# St. Peters Anglican College, Community Hub, Sports & Recreation Centre Project

Eurobodalla Shire Council  
Request for Information (RFI) Report

**Application No.** DA0078/23

**Description:** Alterations and additions to existing educational establishment

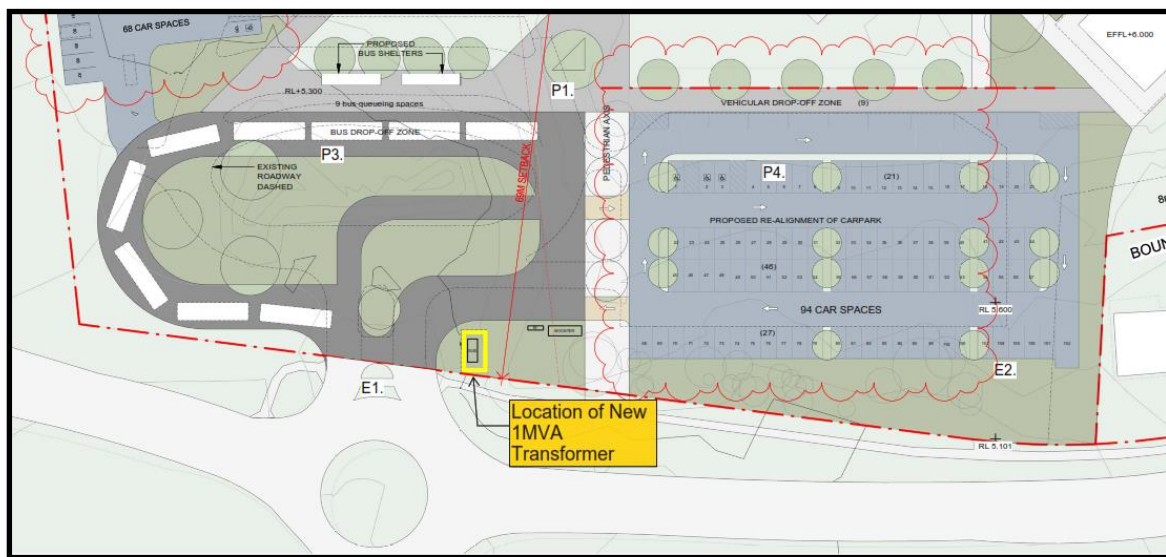
## 1.4. Essential Energy

Acor Consultants have applied for the removal of the existing pole mounted transformer and establishment of a 1MVA pad mount transformer under Essential Energy project number ST0005060. The Design Information Package (DIP) for this project was issued by Essential Energy on 01/09/2022.

The location of the proposed 1MVA pad mount transformer is shown below;

## Flooding

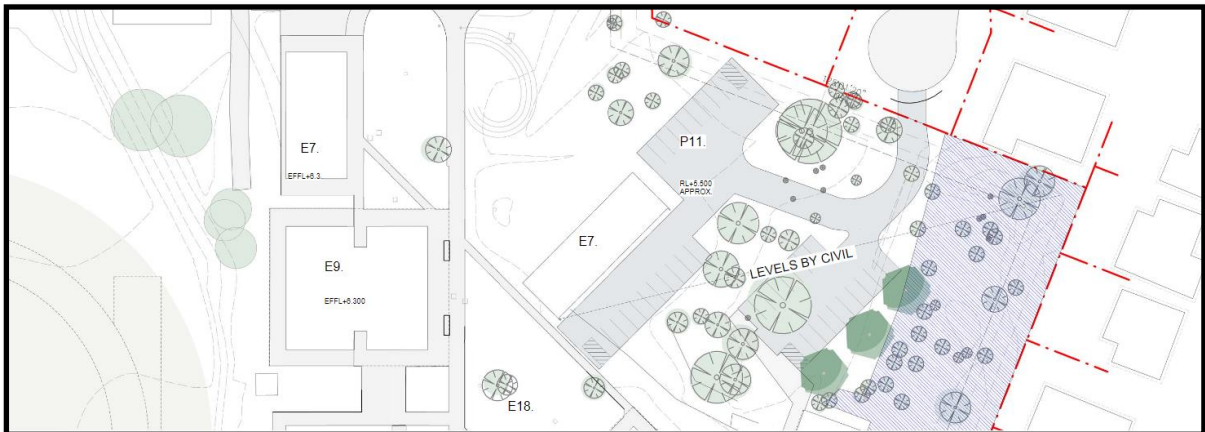
A flooding site constraints plan has not been provided, a clarification received from senior development engineers within the Council have confirmed a discrepancy between the flood model and information available on the GIS mapping. It proposed development generally all have floor levels well above the FPL and outside of the floor affected areas. (parking and access excluded)

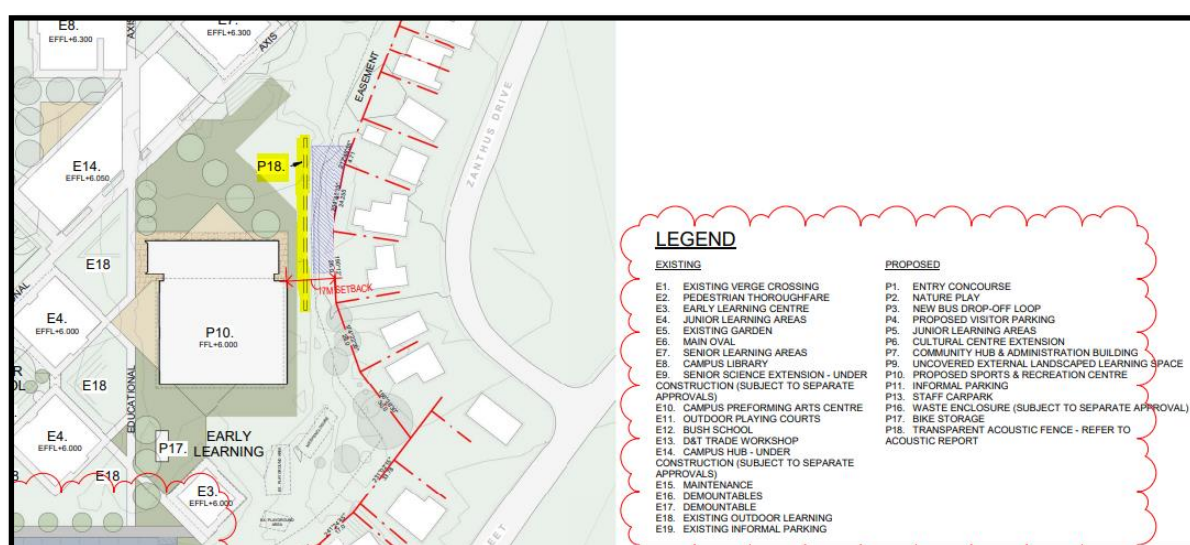
### 2.2. Visual Impact

A Visual Impact Assessment has been prepared as part of this report and can be found;

ST Peters Anglican College  
CHSRC - Site Establishment Plan

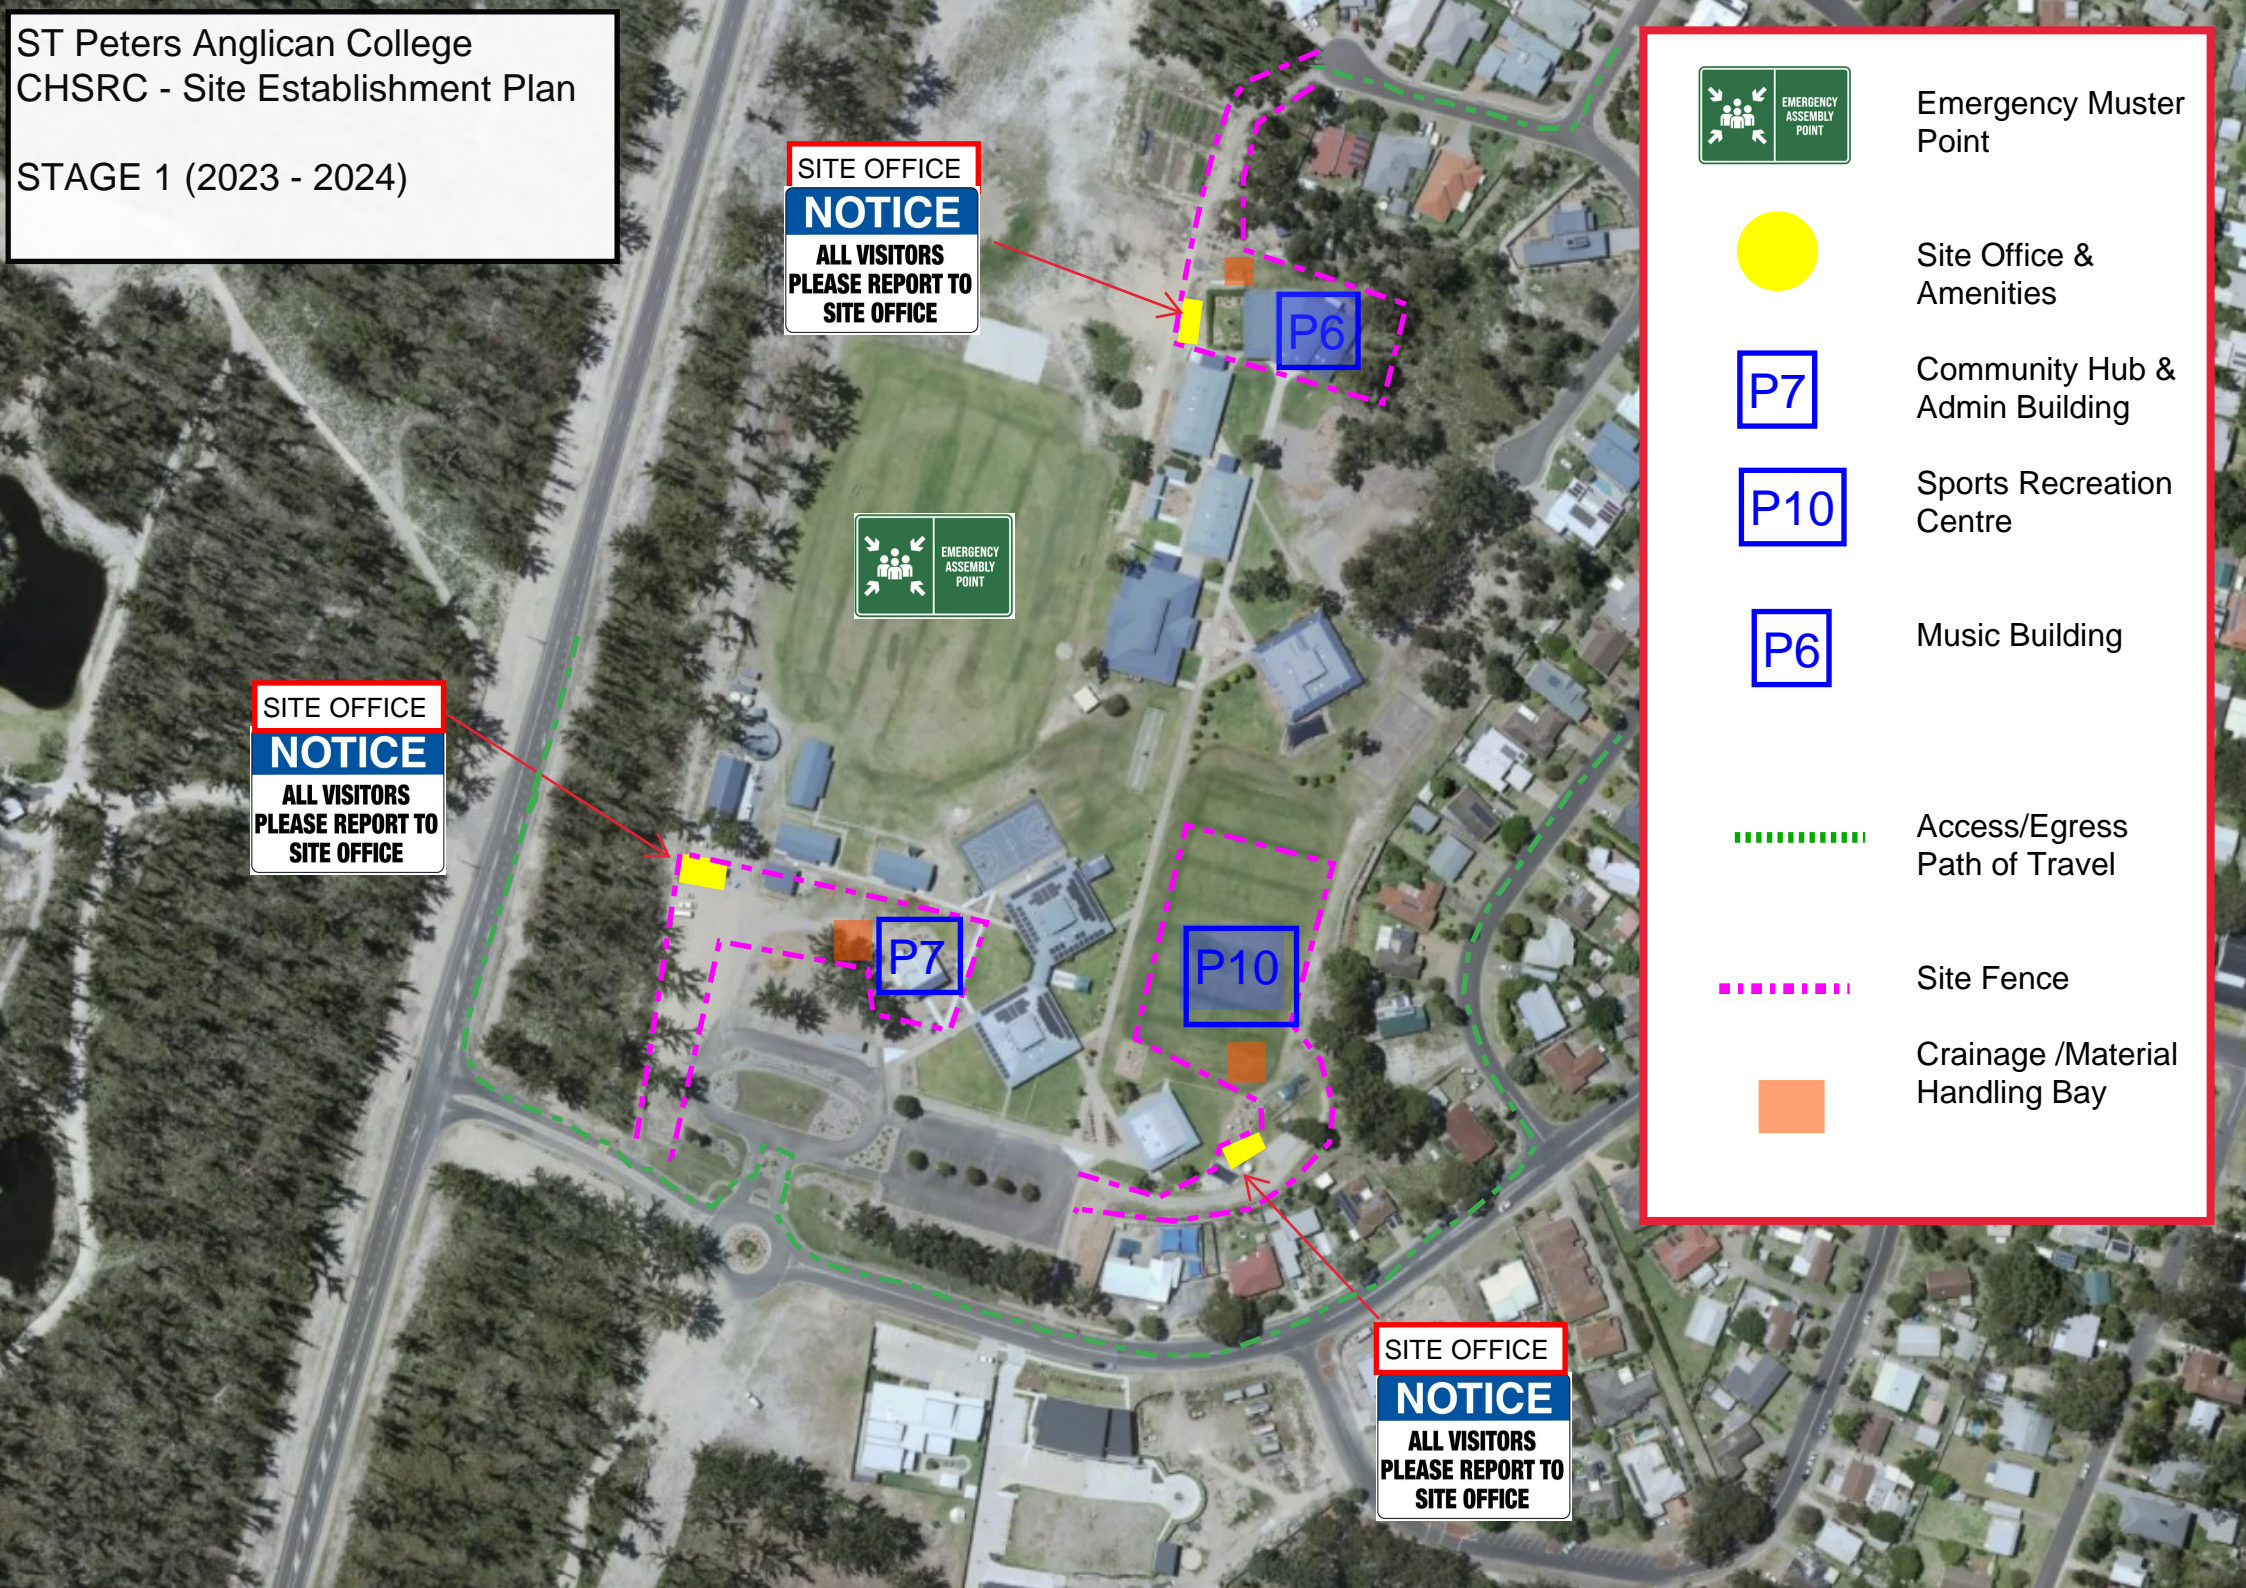
It is proposed the project will be split into four (4) stages of construction as outlined below;

Staging methodology plans outlining the site establishment for each stage of construction have been provided below, these also address the temporary carparking methodology to facilitate ad hoc parking requirements over the December/January holiday period.

STAGE 2 (2024 - 2025)

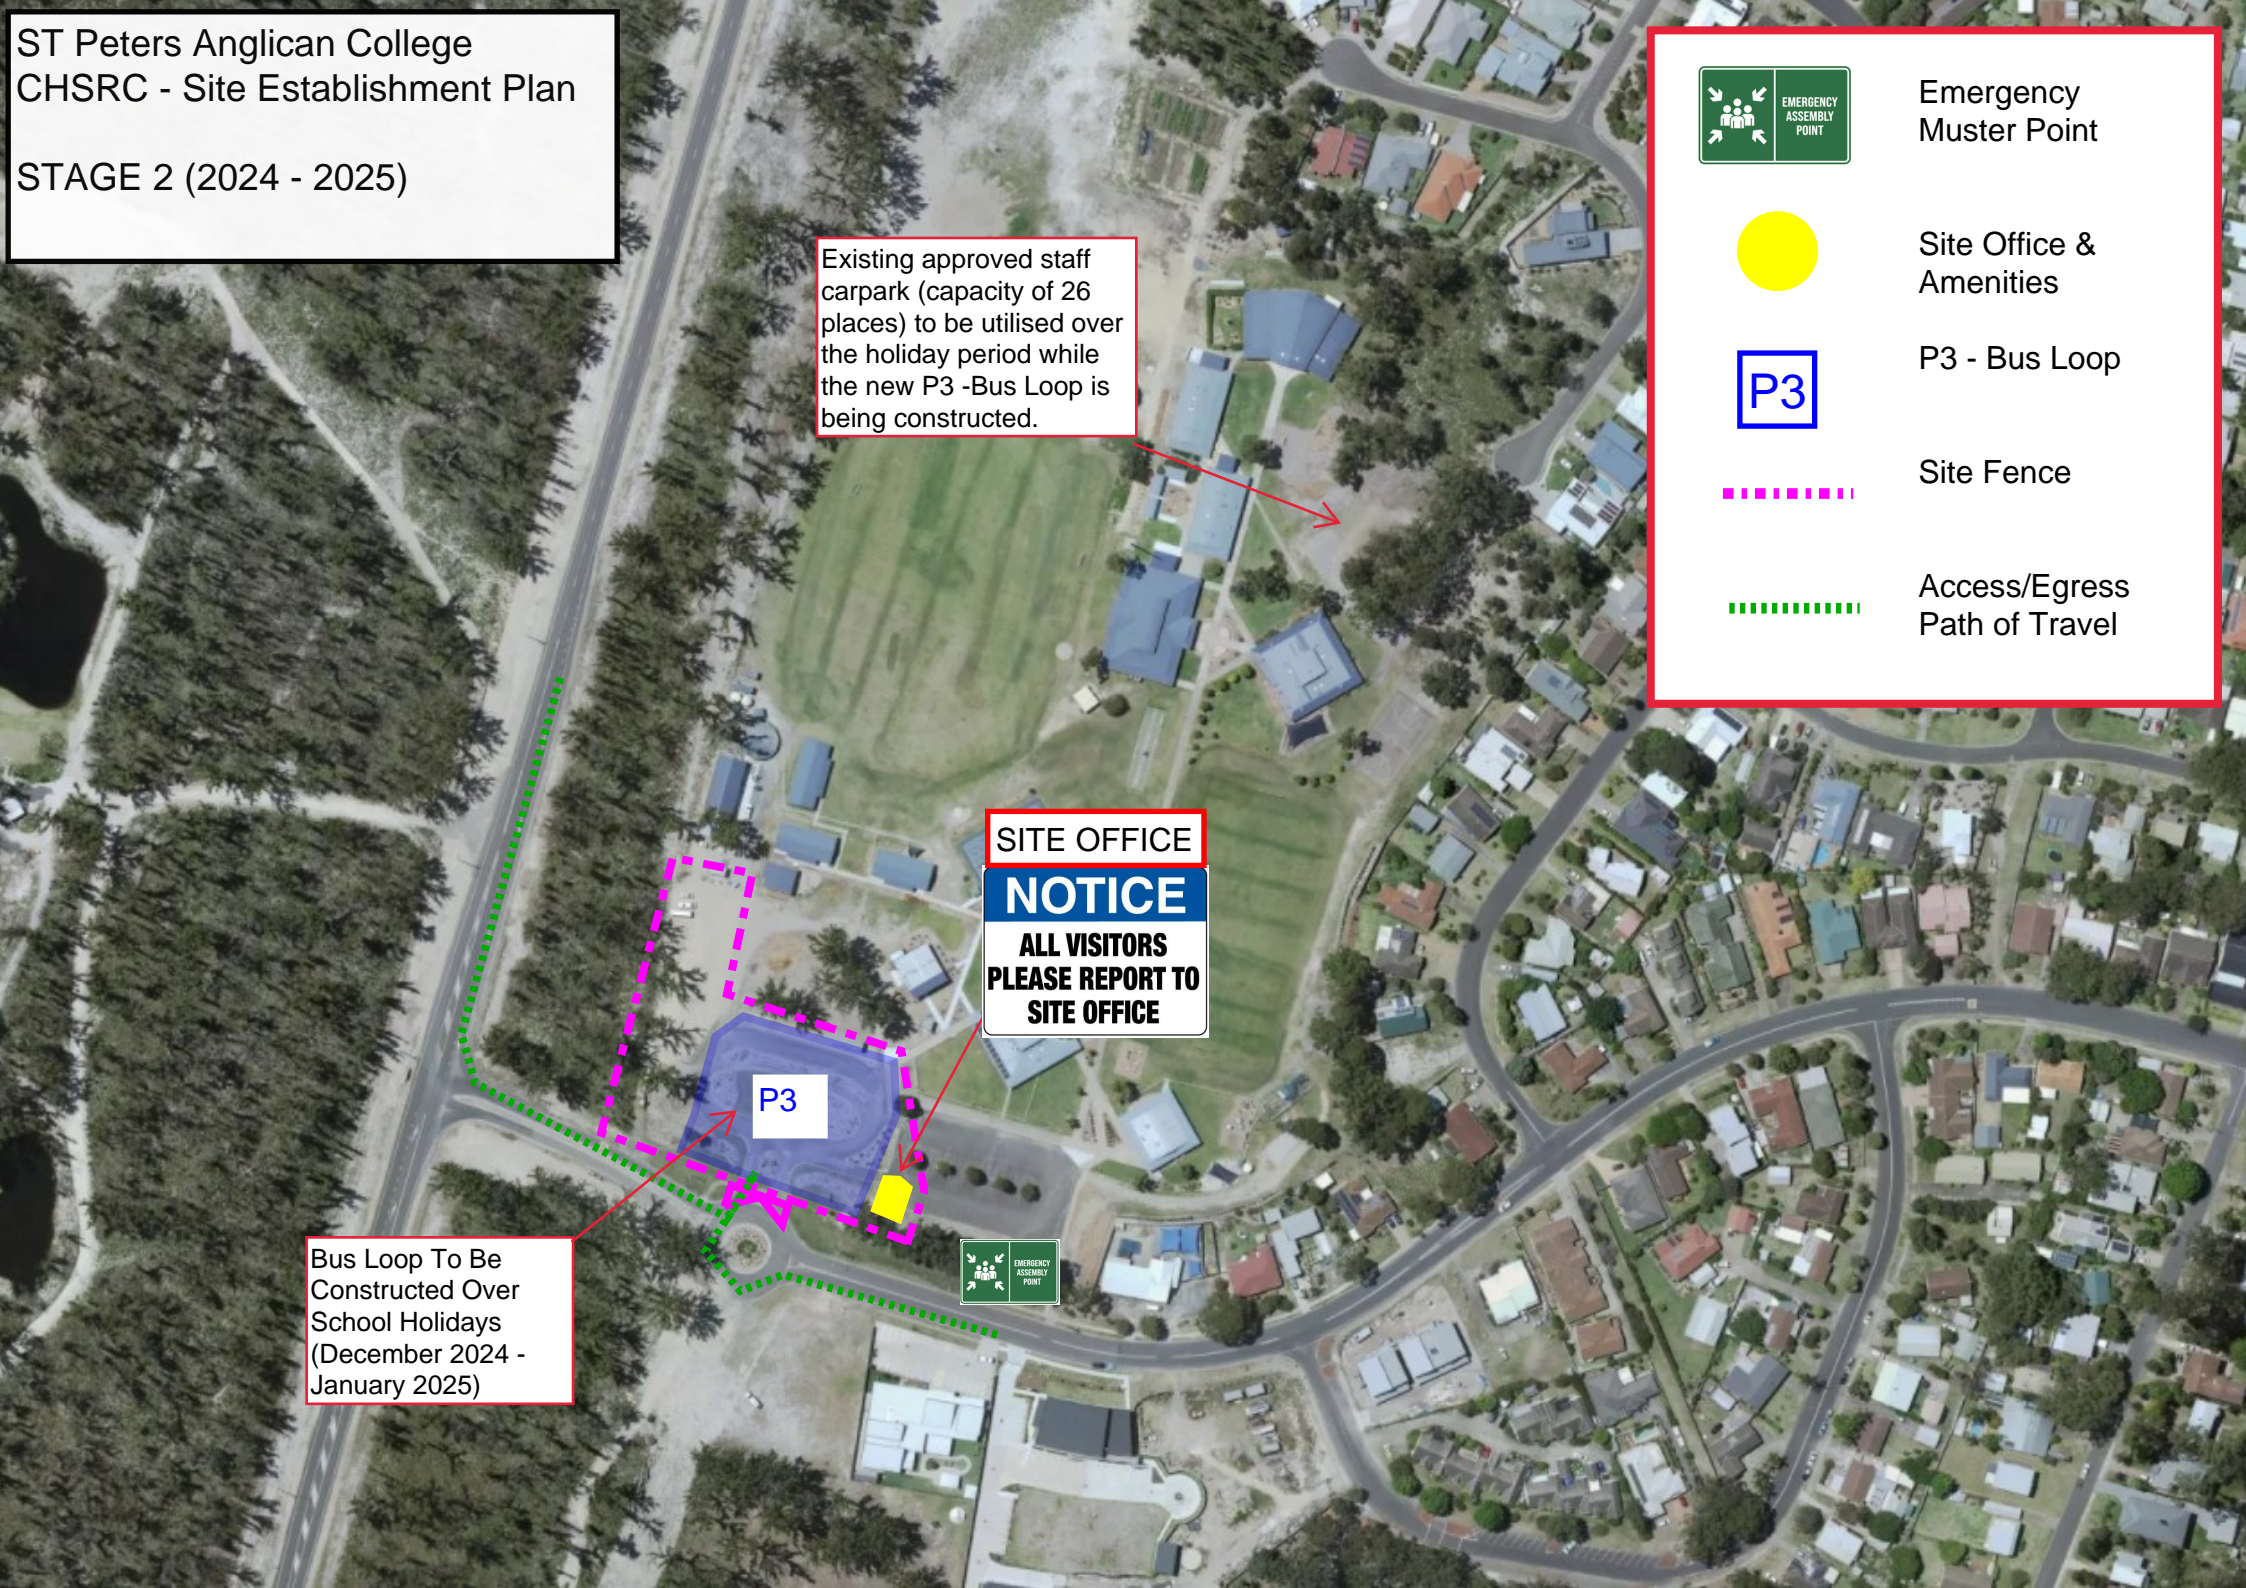
Existing approved staff carpark (capacity of 26 places) to be utilised over the holiday period while the new P3 -Bus Loop is being constructed.

Bus Loop To Be  
Constructed Over  
School Holidays  
(December 2024 -  
January 2025)
